PLAN OF
 PROPOSED SUBWAY
 IN
HOLDEN AVE
 UNDER
 G. T., LAKE SHORE & MICH. CENT'L R.R.'S.

| CITY OF DETROIT DEPARTMENT OF PUBLIC WORKS CITY ENGINEERS OFFICE | | | | | HOLDEN AVE. UNDER BRIDGE XU-6 PENN CENTRAL & GRAND TRUNK WESTERN RR. | | | | |
| WALL SIDEWALK & RAILING REPAIR | | | | | REPAIR PLAN | | | | |

XU6-7

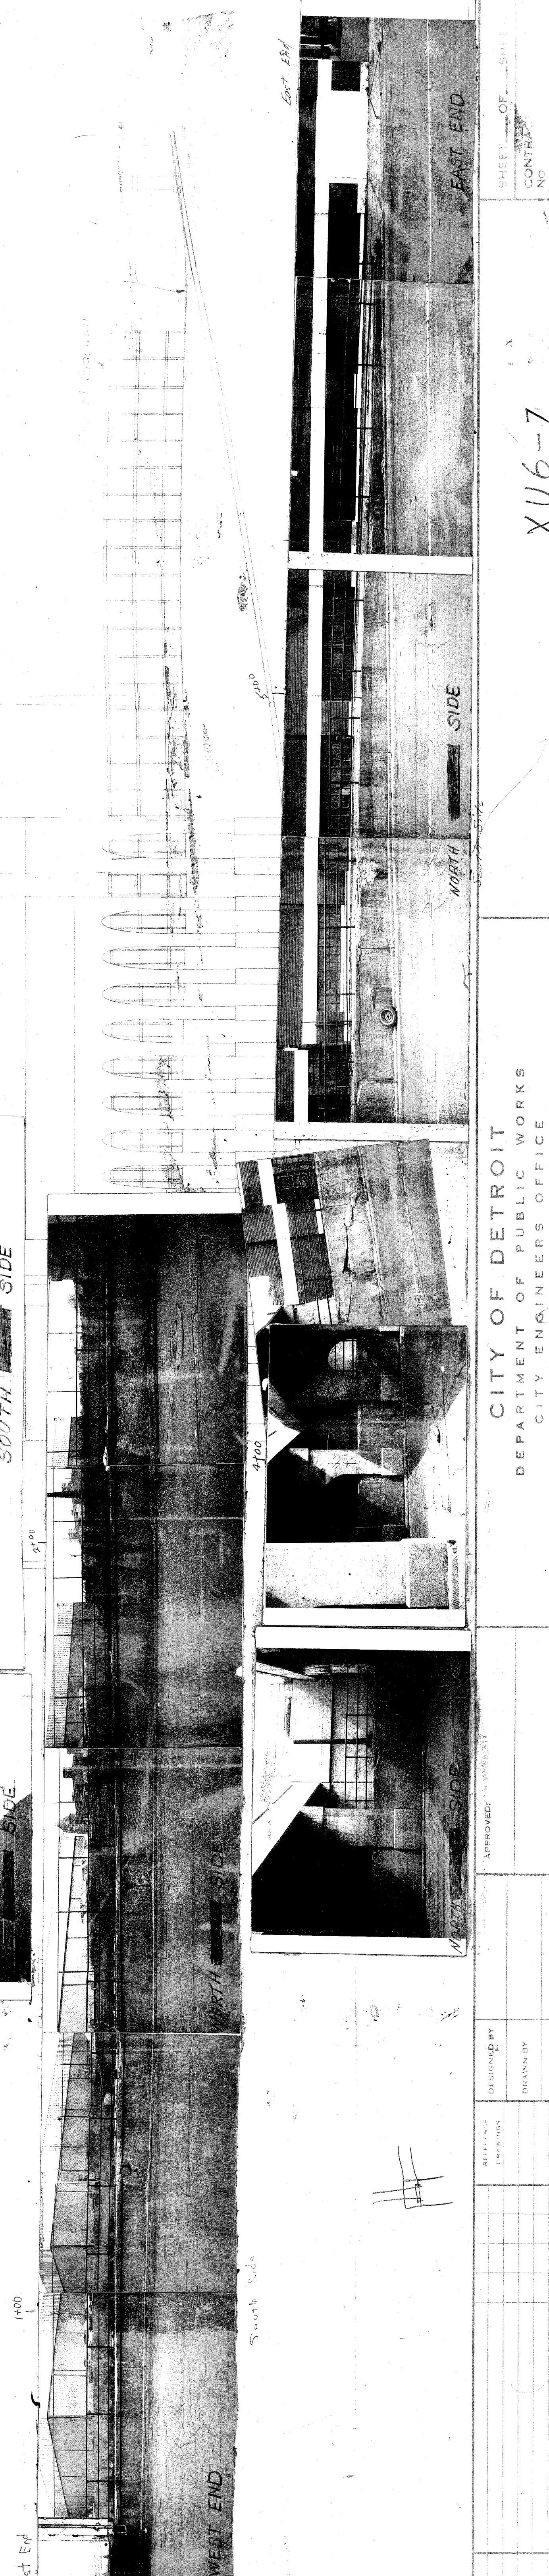
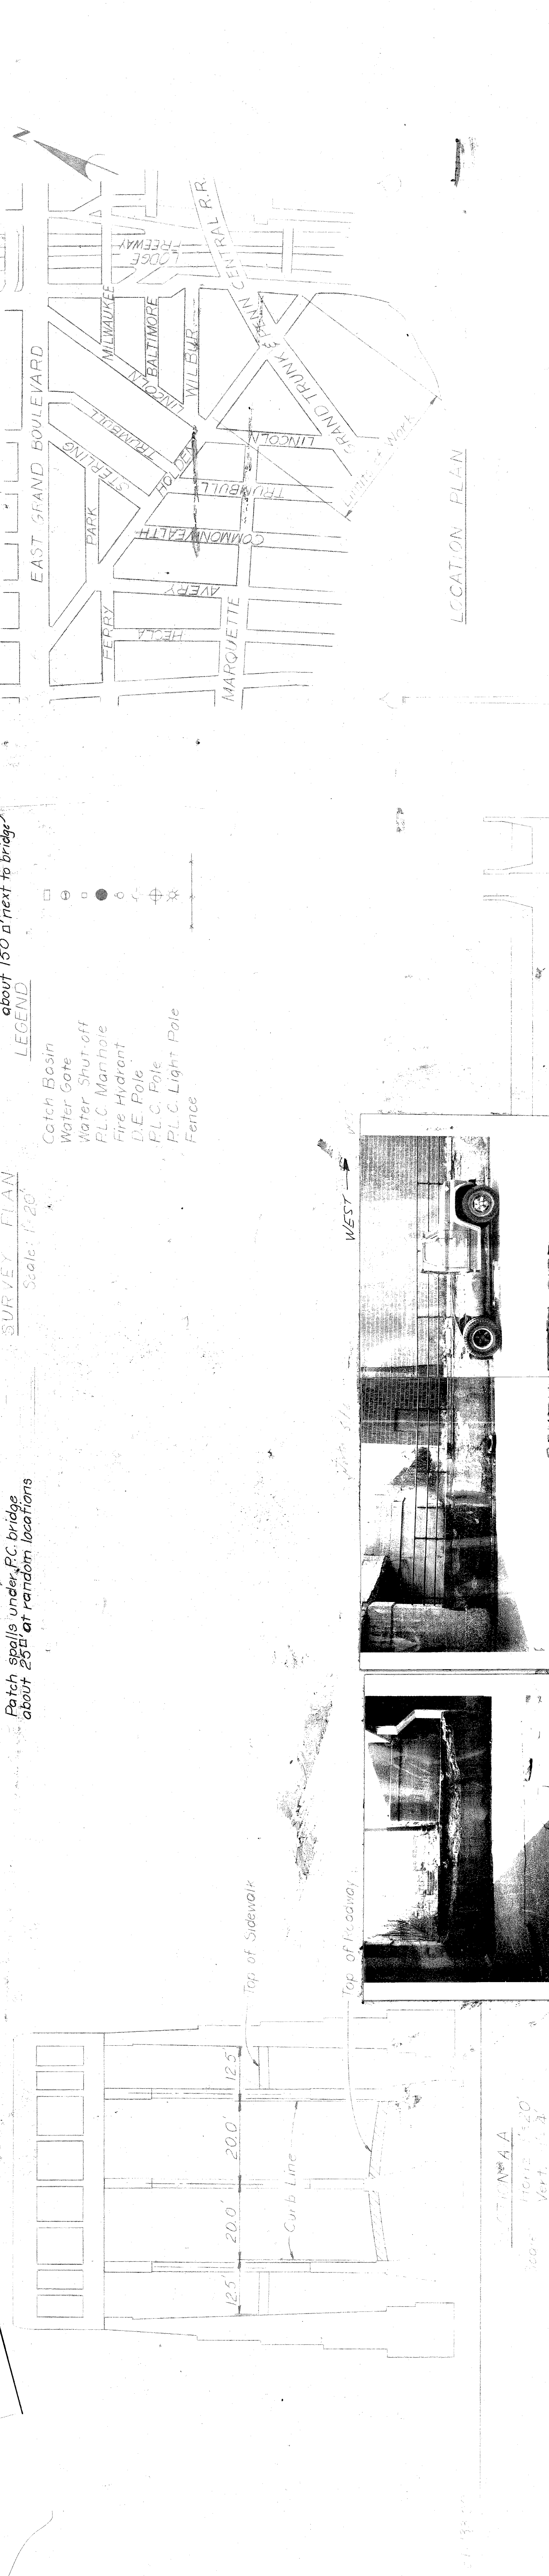
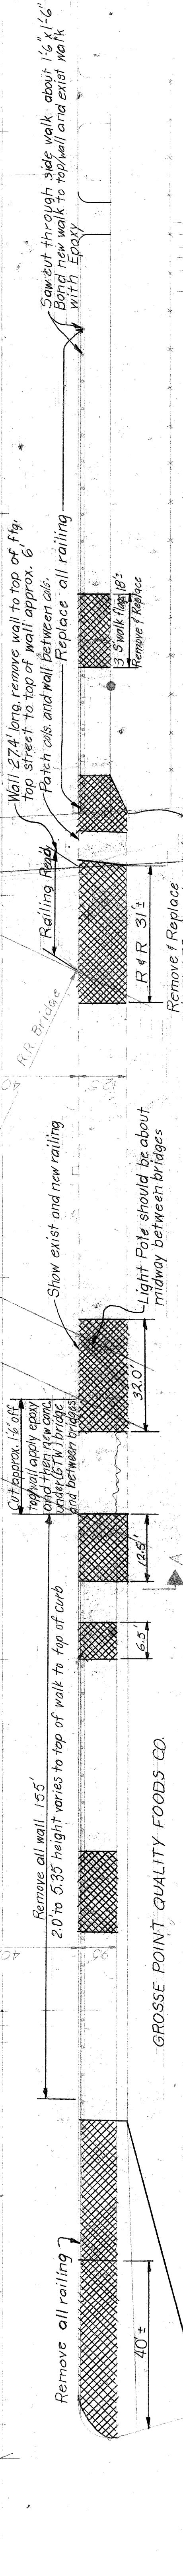
From back end of truck (in picture) to end (West) replace wall (2'-6" top wall to top of curb).
 Replace wall from West end of Grand Trunk R.R. pier westerly for 40'.
 Wall varies from 6' top wall to top part to 4.5' wall, South.

Who will maintain this slope - new growing weed and brush

Recommend building new 6' walk from driveway to bridge

Catch Basins about 1 or more ft. from curb lines. Don't appear to interfere with wall repair work

Save railing between columns of P.C. Bridges - Clean and paint.

Remove & Replace Walk
